PHILADELPHIA ELECTRIC COMPANY
 NUCLEAR GROUP HEADQUARTERS
 955-65 CHESTERBROOK BLVD.
 WAYNE, PA 19087-5691
 (215) 640-6000

March 19, 1992

SUBJECT: Peach Bottom Atomic Power Station, Units 2 and 3
 Clarification of Second Interval ISI Program
 Relief Request

Summary of Changes to PBAPS 2 and 3 ISI Relief Requests

PEACH BOTTOM
TYPICAL MANUAL UT ACCESSIBILITY

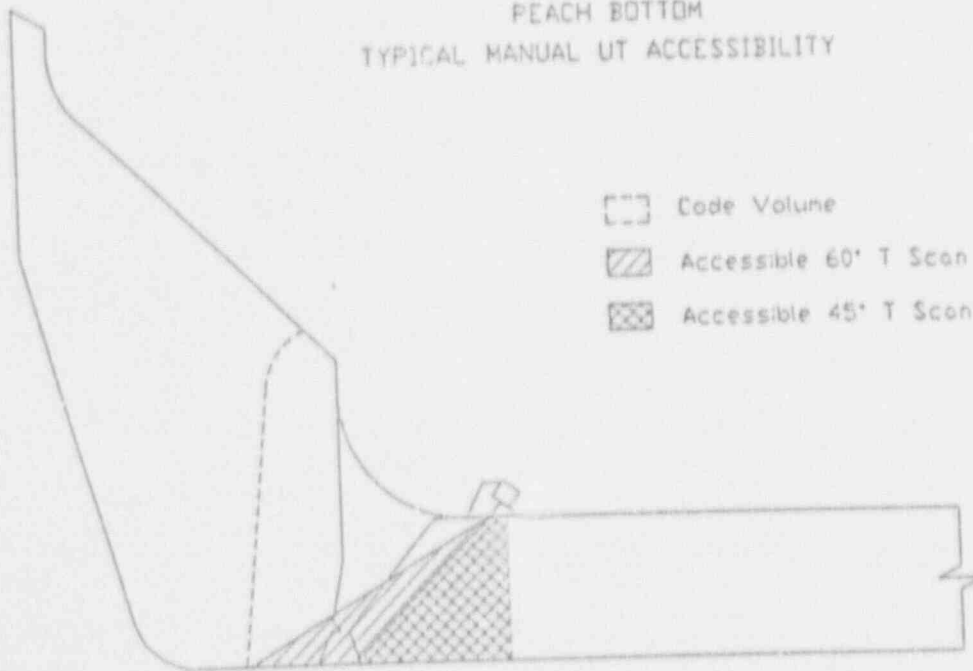
- a) Why are the examination coverages small relative to the Code required examination volume?
- b) Why is the 45 degree parallel scan impractical?
- c) Why is a better examination coverage achieved with the 60 degree transverse scan versus the 45 degree transverse scan?

c) Since examination is only possible from one side of the weld, the 60 degree transverse beam will scan the largest

portion of the Code required volume, as depicted in the drawing on Attachment 1.

As an additional update, this Relief Request has been expanded to define specific examination coverage for each nozzle previously examined. Originally, generic coverages were provided for each group of nozzles. All examination data pertains to volumetric examinations, and is the maximum effective examination coverage which can be achieved given the nozzle configuration. Attachment 1 provides a diagram of the nozzle to vessel weld configuration, along with an indication of the maximum extent of manual coverage which can be achieved versus Code requirements. As indicated, the 60% transverse scan produces the maximum coverage of the Code required volume.
